# WRITTEN REPRESENTATION FOR SPR EA1N and EA2 PROJECTS (DEADLINE 1)

## NOISE

**Interested Party:** SASES    **PINS Refs:** 20024106 & 20024110

**Date:** 1 November 2020

Figure 1

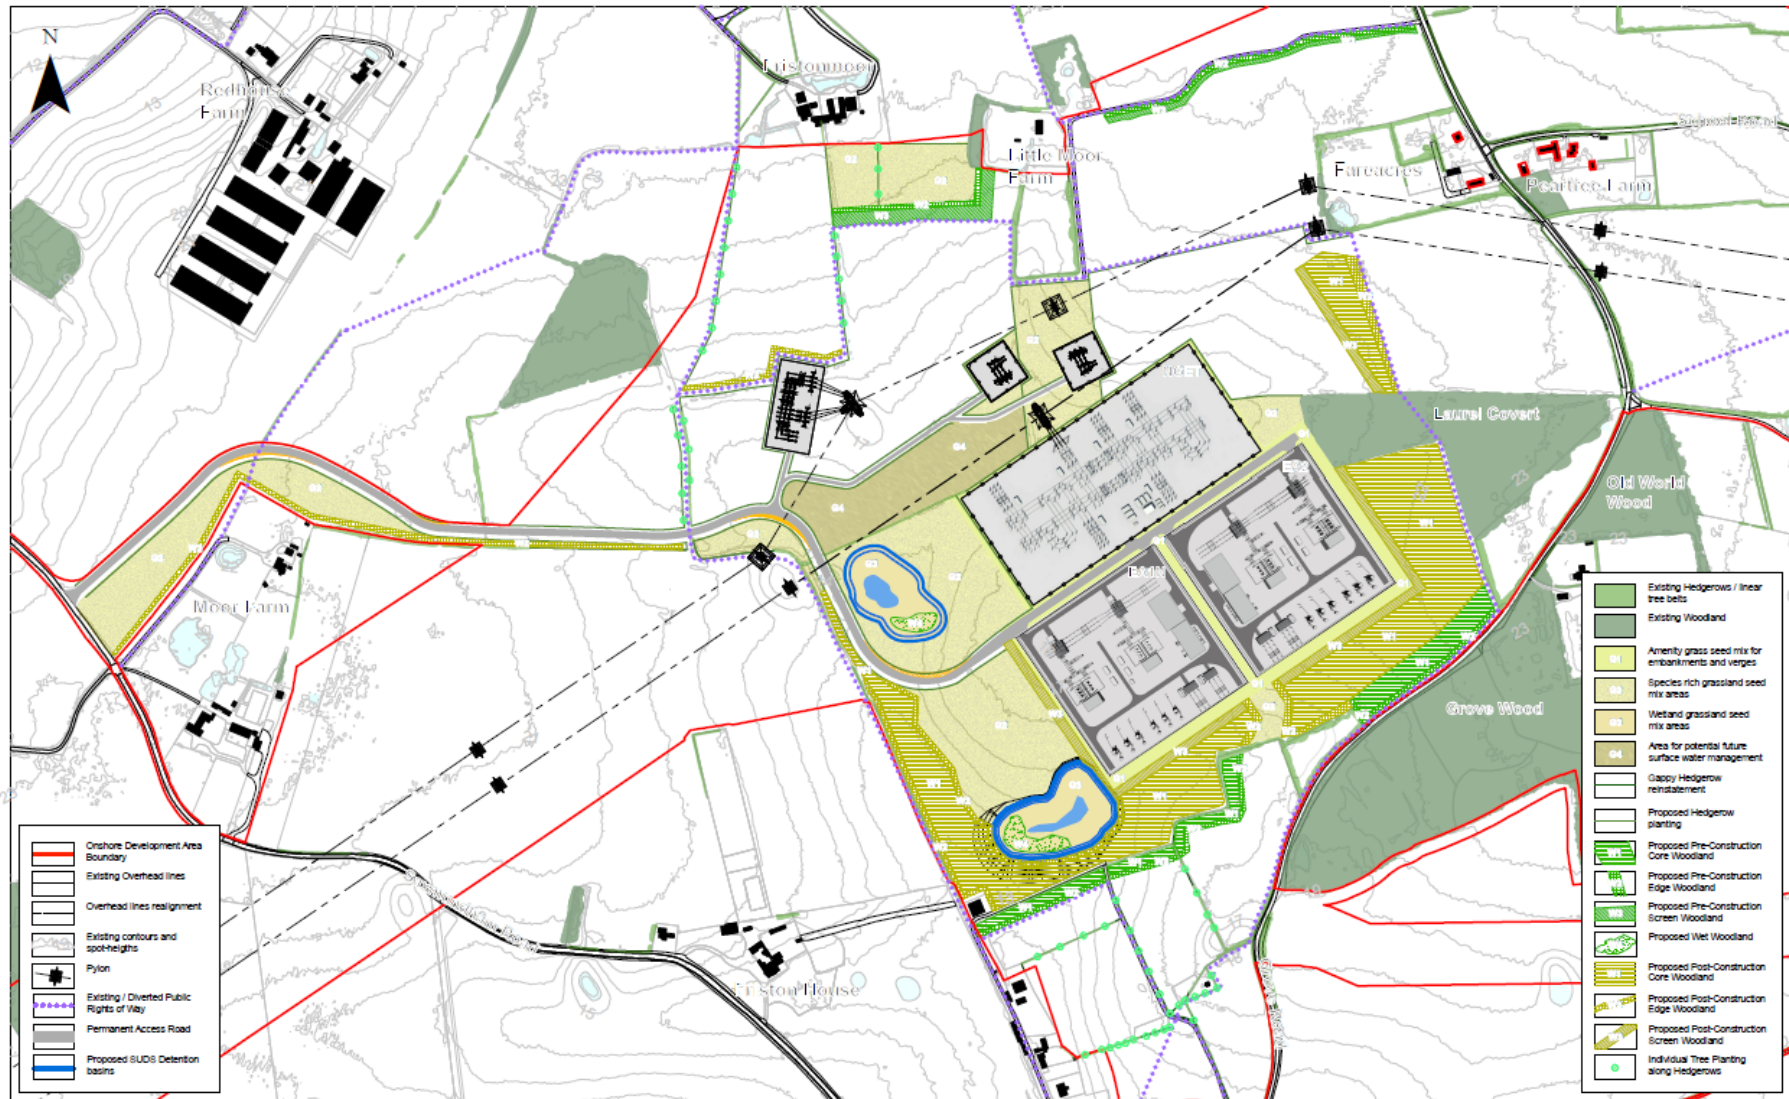
1. The project comprises 2 x 10 acre SPR substations, equipment up to 18m high + NGET substation (similar size) + multiple sealing end compounds and a new pylon all very close to a long-established village with a Grade 2\* parish church and graveyard, and some residential property within 250m of the substations themselves (Figure 1 below).
